**South Cambridgeshire Planning Services**  
Submitted Online

**18-July-17**

**S/2403/17/FL office, retail, public realm, 125 car park - Cambridge North Station**

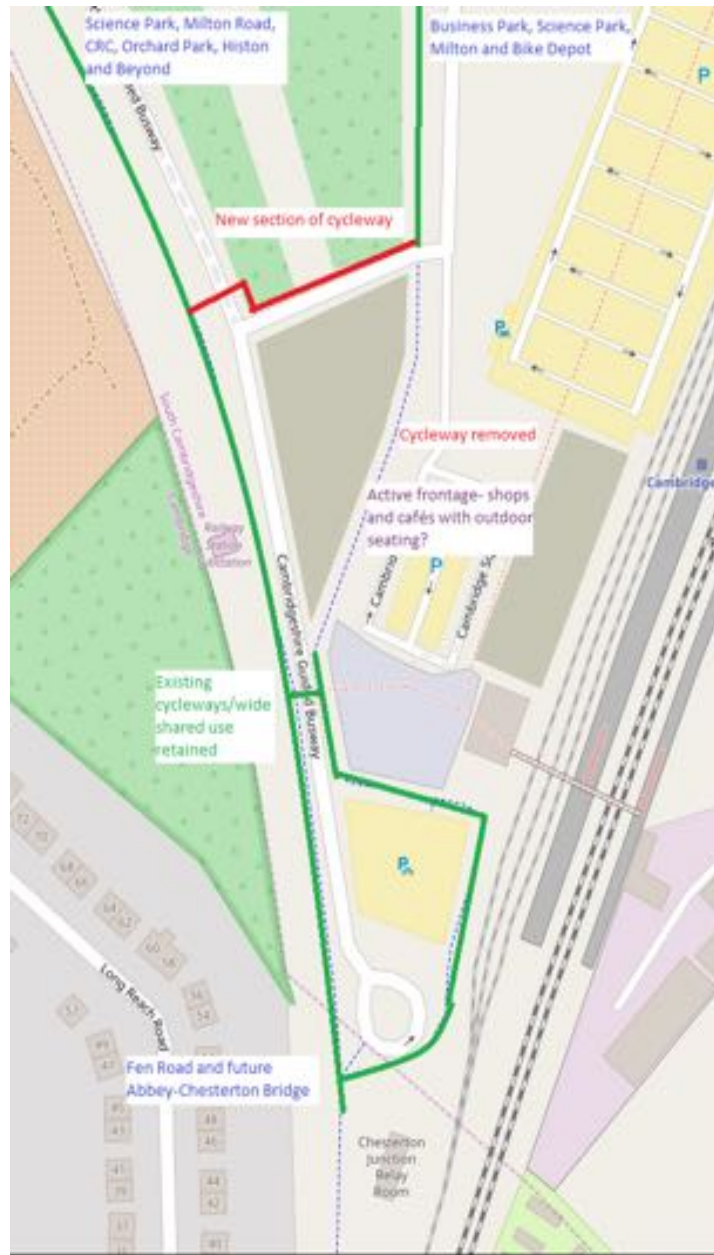
Currently along the station-square side of the site there is a 3m cycleway, finished in smooth tarmac, and a 2m footway, separated by an inset kerb. This is already a well-used cycle route, both by station users and those simply travelling

We are concerned that applicant's documentation appears to misrepresent the construction of the existing provision as a block paved shared space.

The applicant seeks to effectively sever this, replacing it with very poor quality provision. This is summarized in the diagram

The proposed detour is a very poor alignment compared to the existing route. Not just a dog leg, it briefly involves doubling back.

We urge that the site and building on it are fundamentally redesigned. It should incorporate, unobstructed, the existing cycleway and fix the existing crossings of the busway and the spur from Milton Avenue to the busway. These should be continuous across the road, “Copenhagen” style, with clear priority for pedestrians and cyclists.
